## INLAND WETLANDS AND WATERCOURSES APPLICATION

**PROJECT DESCRIPTION** (general purpose) Replace the temporary Sonotubes with properly installed permanent footings, supports, and beams. Replace decking, roof, walls, and screens if needed. The work will be conducted on and under the existing porch.

12 Old Mill – CC-26-02-COM Revisions Email Summary Feb 17, 2026'

## RESPONSES TO THE SITE WALK COMMENTS, DATED FEB. 14, 2026

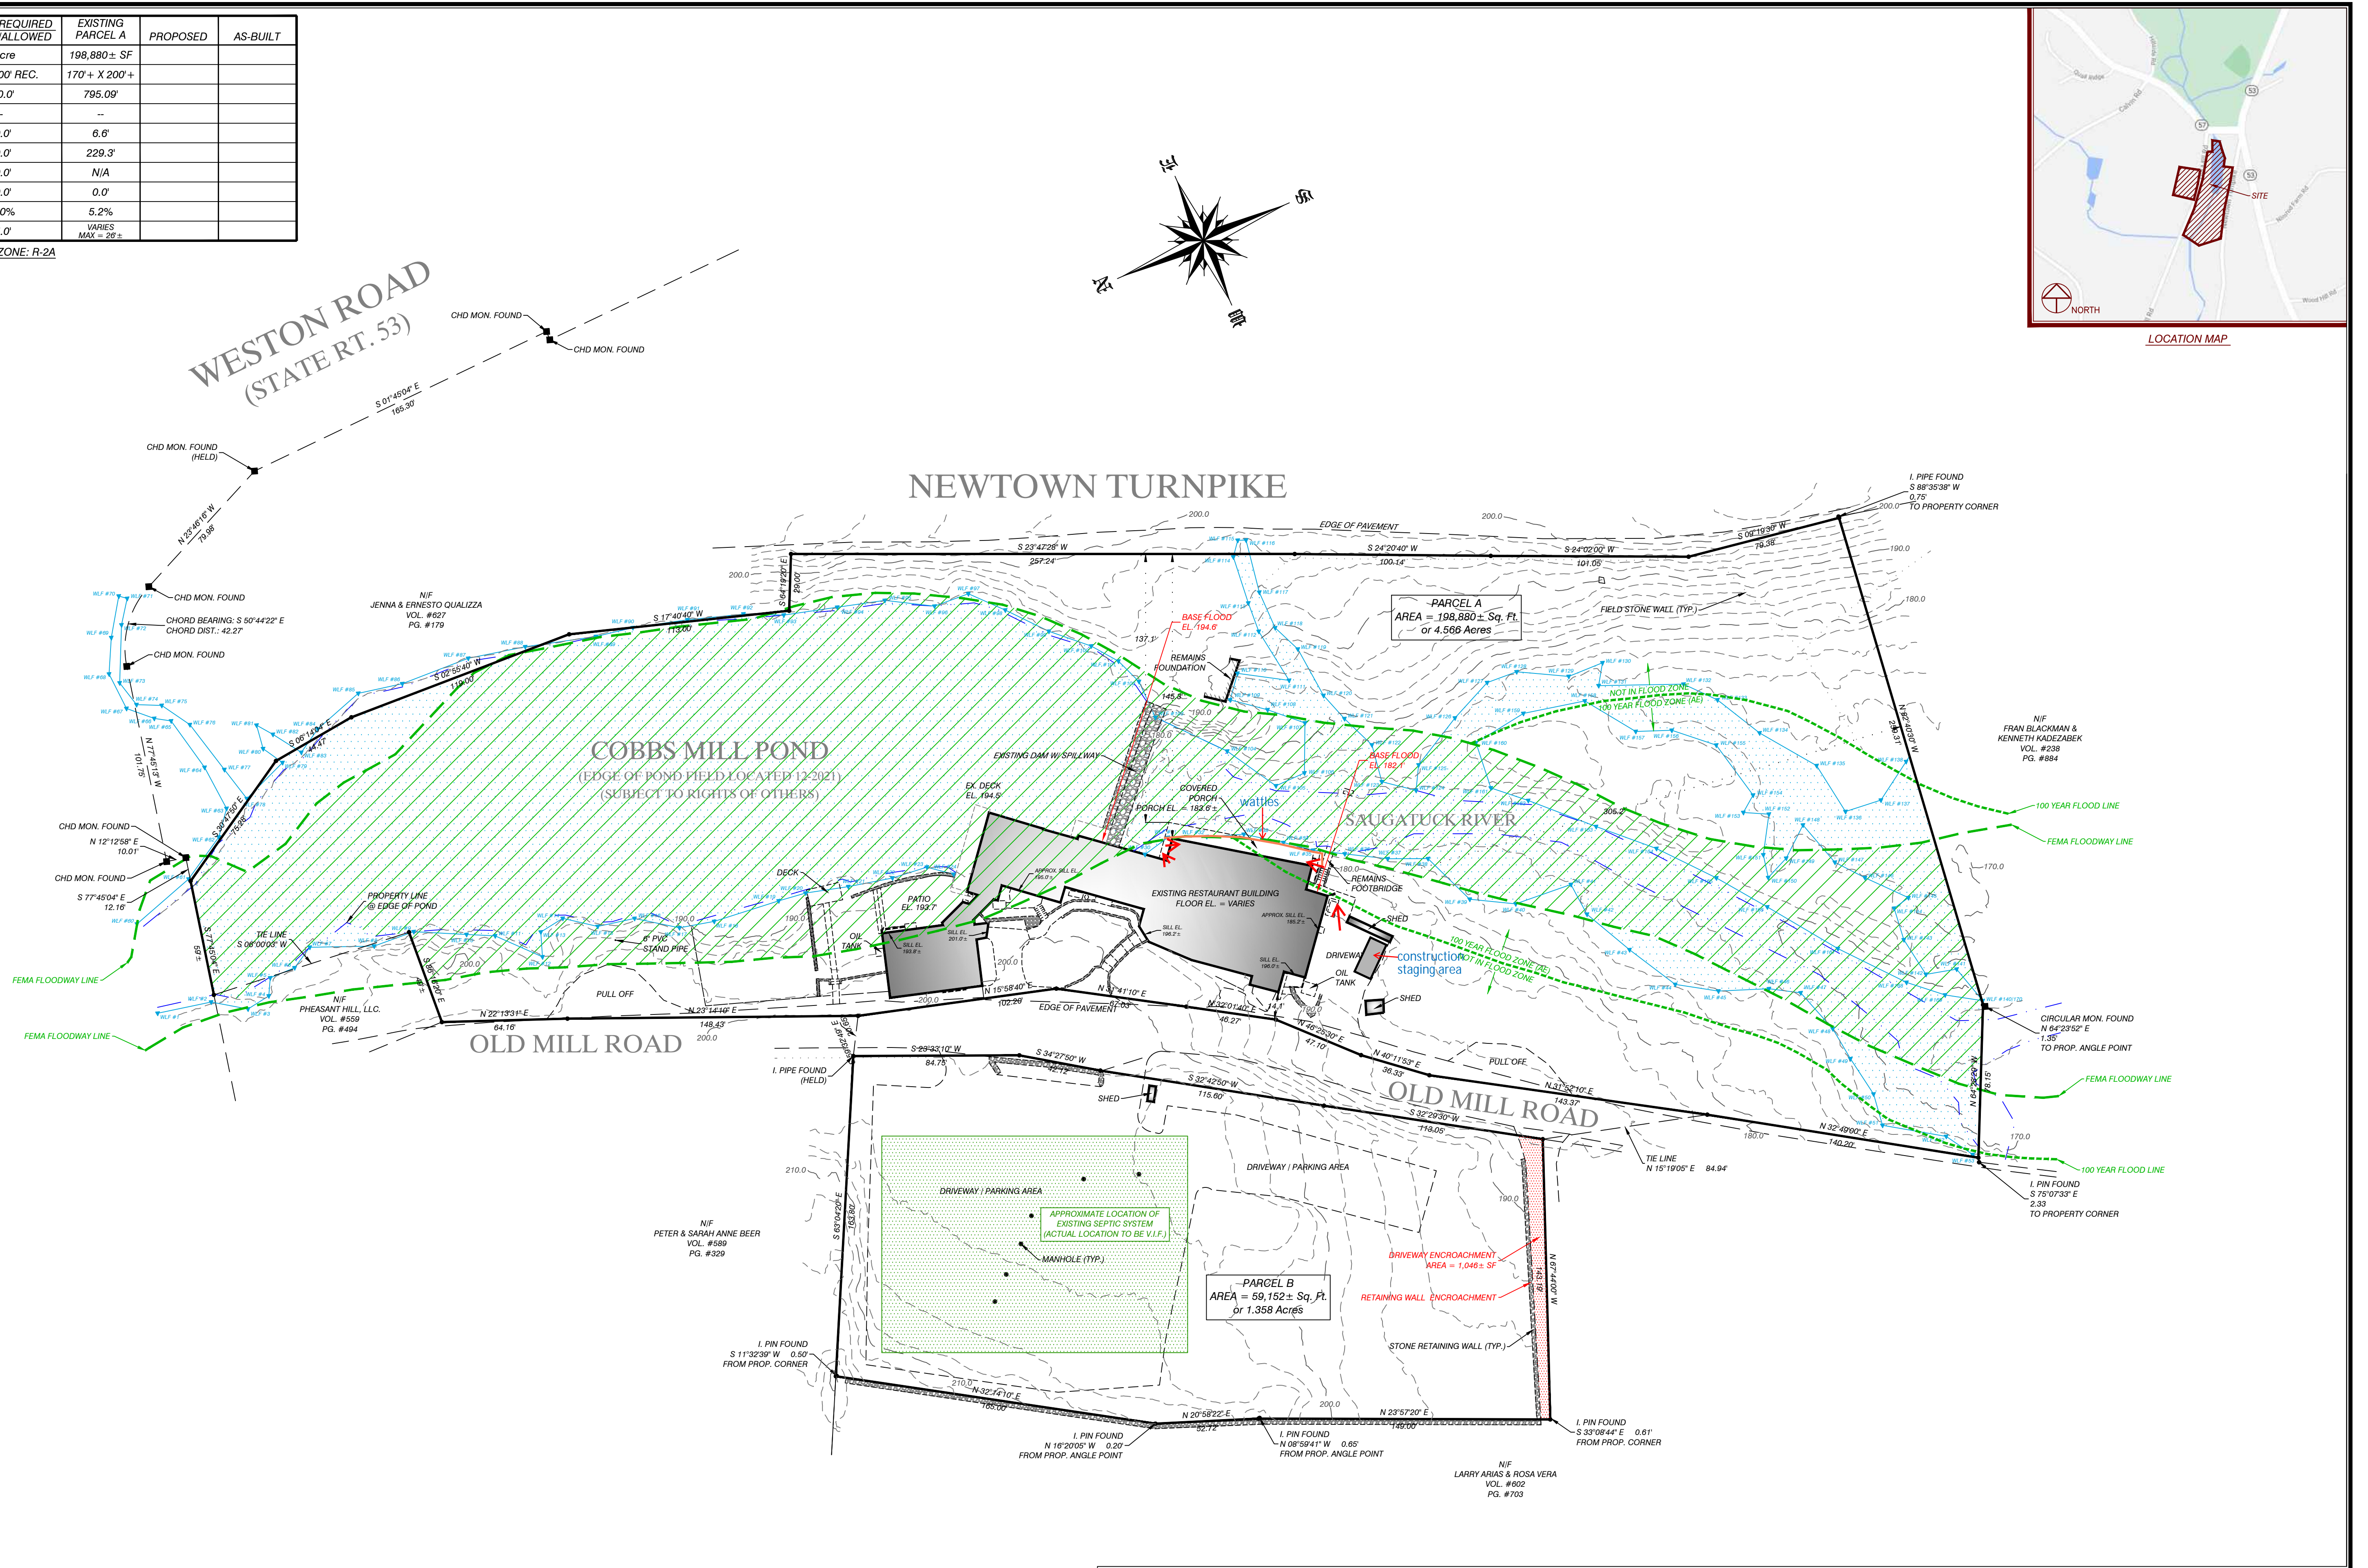
- What is the overall construction sequence for the project including supporting the structure above the supports while work takes place? How will the application control erosion and sedimentation during the project and limit project area to protect the watercourse nearby and downstream?*

The construction sequence is provided in the project narrative under "Project phasing." Soil erosion and sediment control measures are also explained in project narratives and shown on the revised existing

conditions survey, dated December 16, 2024.
